Problem

Case (a)

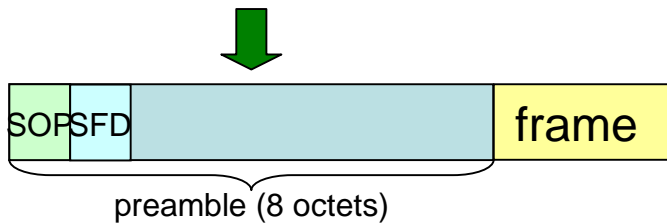
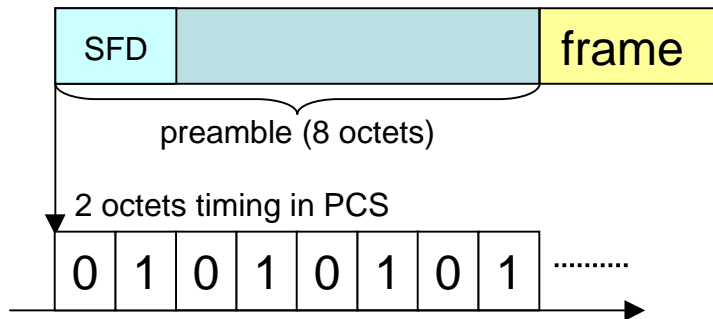
- The preamble may be 7 or 8 octets long on the transmission side because of the PCS function. The PCS performs with 2 octets timing.
- In both case, SOP code substitute for the first byte.

- In case (a), SFD can be transparently transferred to the receiving side.
- In case (b), SFD is overwritten with SOP code. As a result, *there is no delimiter which can indicate start of preamble.*

- Length of SFD
 - 2 octets long → 3 octets long
- Calculation range of preamble CRC
 - entire preamble → 3rd – 7th octets in preamble
(1st and 2nd octets are excluded.)
